Access Compliance Report

Public Rights-of-Way

(Curb Ramps)

Intersection ID: 30180	Main Street: ACORN_VALLEY_CT	Cross Street: HIDDEN_CREEK_DR	Location: NE
ADA ID: 60780F2A177F	Ramp Type: BlendTrans1	Initial Pass/Fail: Fail	Overall Compliance: No
			Severity Score: 21.25

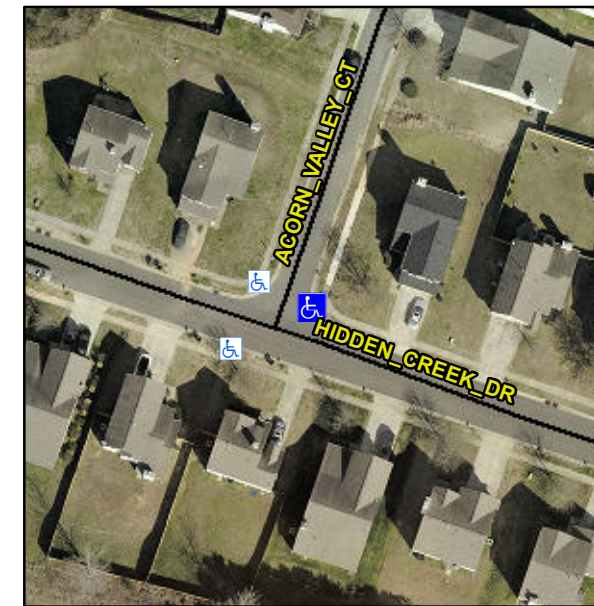
Not Found, R304.5.1, R304.5.3

Compliance	Description	Data	Compliance	Description	Data
N/A	Ramp Length (in)	48.0	Yes	BlendTrans Slope (%)	3.6
No	Ramp Width (in)	38.5	No	BlendTrans XSlope (%)	6.0
N/A	Flare Type LT	N/A	N/A	Flare Type RT	N/A
N/A	Flare Slope LT (%)	N/A	N/A	Flare Slope RT (%)	N/A
N/A	Flare Traversable LT?	N/A	N/A	Flare Traversable RT?	N/A
N/A	Landing Length (in)	N/A	N/A	DWS Provided?	N/A
N/A	Landing Width (in)	N/A	N/A	DWS Contrast?	N/A
N/A	Landing Slope (%)	N/A	N/A	DWS Length (in)	N/A
N/A	Landing X Slope (%)	N/A	N/A	DWS Full Width?	N/A
N/A	Landing Curb? (Y/N)	N/A	N/A	DWS Offset (in)	N/A
N/A	Shared Landing?	N/A			
N/A	Gutter Ponding?	N/A	N/A	Gutter Slope (%)	N/A
N/A	Gutter Lip Ht (in)	N/A	N/A	Gutter X Slope (%)	N/A
N/A	Painted X Walk1?	No	N/A	Painted X Walk2?	No
	X Walk 1 Direction	To NW		X Walk 2 Direction	To S
	X Walk 1 Width (in)	N/A		X Walk 2 Width (in)	N/A
	X Walk 1 Slope (%)	2.2		X Walk 2 Slope (%)	4.0
	X Walk 1 X Slope (%)	2.2		X Walk 2 X Slope (%)	4.0

N/A	Ramp inside XWalk1?	N/A	N/A	Ramp inside XWalk2?	N/A
	Road Slope (%)	4.7		Clear Space?	N/A
	Road X Slope (%)	0.7	N/A	Clear Space to XWalk (in)	N/A
N/A	Any Obstructions?	N/A	N/A	Storm Grate/Utility Hazard?	N/A
	Obstruction Type			Storm Grate/Utility Type	
		N/A			N/A
			Yes	Surface Condition? (G/P)	Good
			No	Curb Slope (%)	19.1

Remove & Replace Curb Ramp With Two New Directional Ramps or Equivalent.
